### REMARKS

Appl. No. 09/837,733  
Amdt. Dated August 25, 2003  
Reply to Office Action of May 23, 2003

Docket No. RTN-154PUS

FIG. 2

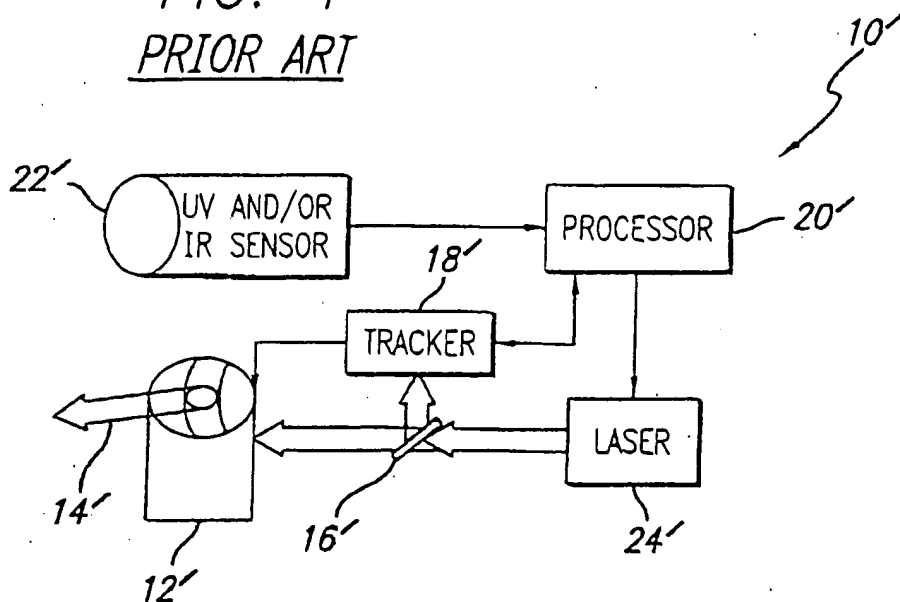
Applicants have also amended the specification on page 8, line 25, to replace the terms "beam path 60" with the terms --beam path 61--. Furthermore, Applicants have amended Fig. 2 to replace the term "60" with the term --61--, which is consistent with the above-described amendment to the specification. Accordingly, Applicants have submitted herewith a clean copy of Fig. 2 reflecting the above amendment and respectfully request that this clean copy of Fig. 2 be approved and substituted for the current Fig. 2 of the present application. No new matter has been added.
